Service Bulletin

Bulletin No.: PI0216A

Subject: Locating/Repairing Noise or Rattle from Rear of Vehicle When Driving over Rough Surfaces

Models: 2011 Buick Regal
Built Prior to VIN Breakpoint B1013646

2523039

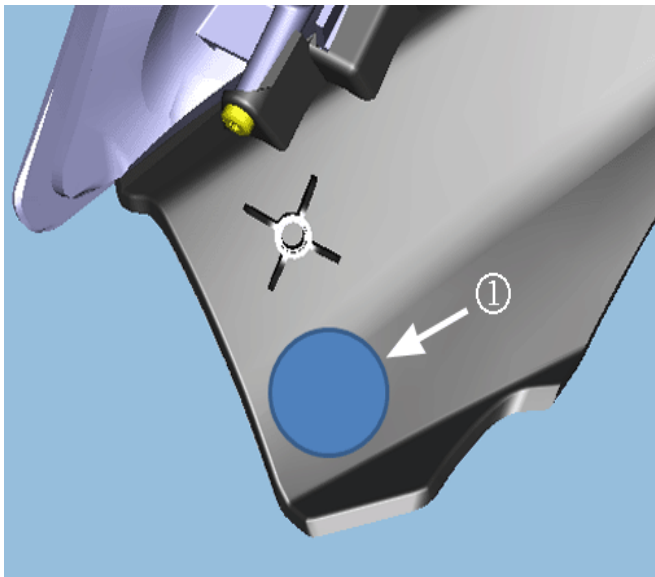
The cause of this condition may be that the upper corner (1) of the left or right tail lamp is contacting the body sheet metal when the vehicle is driven on rough roads. Lightly pressing on this area of the lamp will often verify the condition.

Earlier builds may have no bumper/insulator in this area and later builds may have a hard rubber bumper on the underside of the lamp housing, which may have shifted or come loose.

2523042

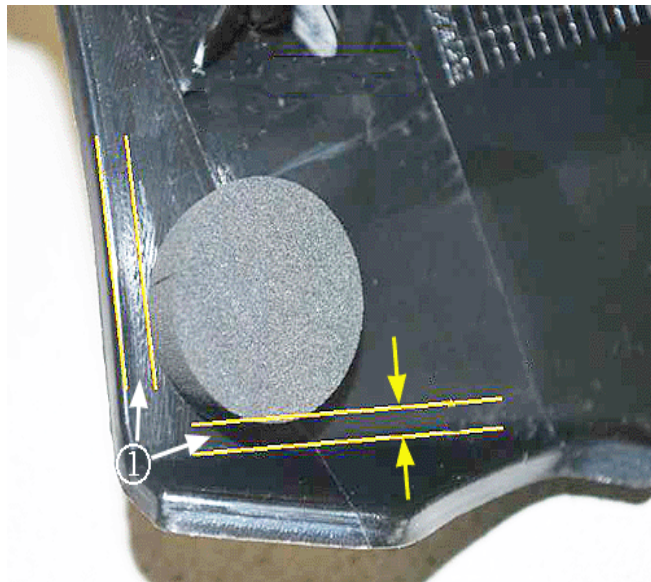
To insulate the tail lamp from rattling against the sheet metal, technicians are to install a foam insulator pad. Add the foam pad (1) to the underside of the black applique on the tail lamp following the steps below:
